Re: Response to Ecology July 25, 2017 Opinion Letter

Former Tosco Bainbridge Island Bulk Plant 1784
Weaver Avenue & Shepard Way NW
Bainbridge Island, Kitsap County, Washington
Cleanup Site ID No. 3690
Facility/Site ID No. 26595127
VCP Site NW3070
Project Number: 81177343

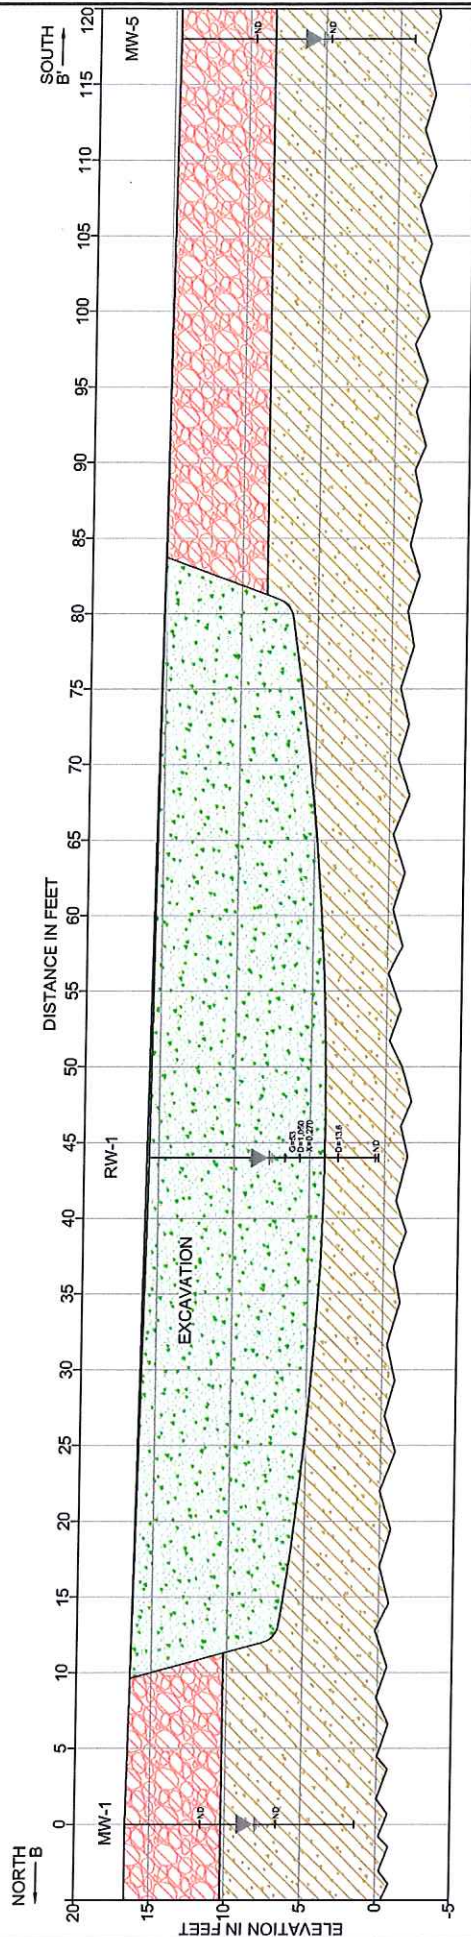
- *Ecology recommends using different colors for the lithologies presented in the two cross-sections (Exhibits 3 and 4). Ensure the cross sections accurately portray the slope of the sidewalls so that it is clear where and to what depth contaminated soil was removed.*

- *At least one cross-section showing the excavation limits with confirmation soil sampling locations and analytical results should be provided.*

Response: Please see the revised Exhibit 3 and Exhibit 4 Cross-Section diagrams that have been updated with different colors, and to accurately depict the slopes of the soil removal excavation sidewalls.

Response: Please see the revised Exhibit 3 Cross-Section diagram with confirmation soil sampling locations and analytical results added.
